Addendum No. 02

Jefferson Barracks – Readiness Center Interior Renovation
(St. Bernadette)
St. Louis, MO
PROJECT NO. T2504-03

2. A-401 ENLARGED FLOOR PLANS

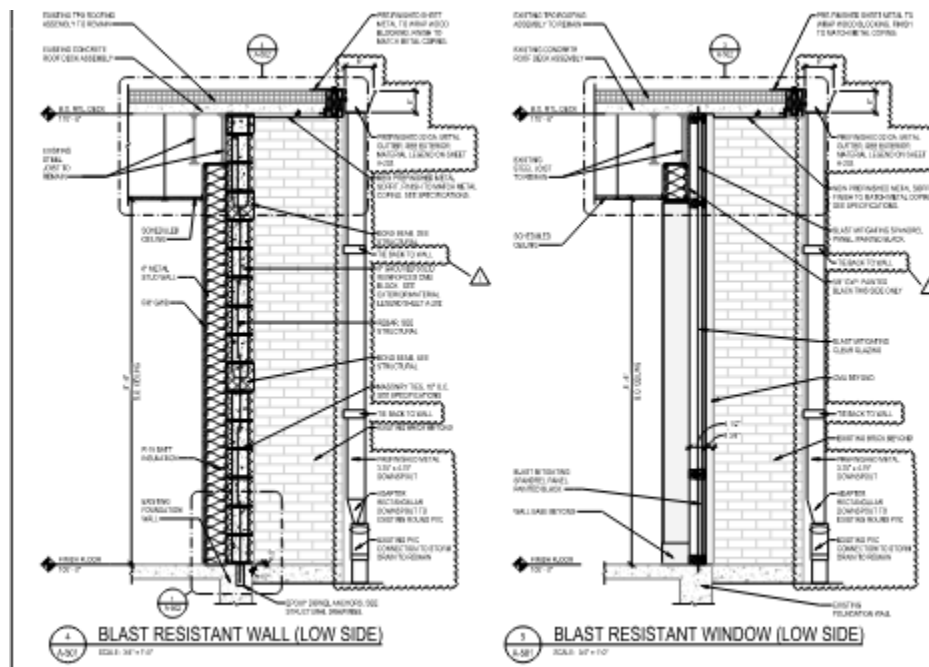
DELETE: PLAN KEYED NOTES: No. 8 – “TROUGH SINK. SEE SPECIFICATIONS AND PLUMBING DRAWINGS FOR MORE INFORMATION.”

ADD: PLAN KEYED NOTES: No. 8 – “TROUGH SINK. SEE PLUMBING DRAWINGS FOR MORE INFORMATION.”
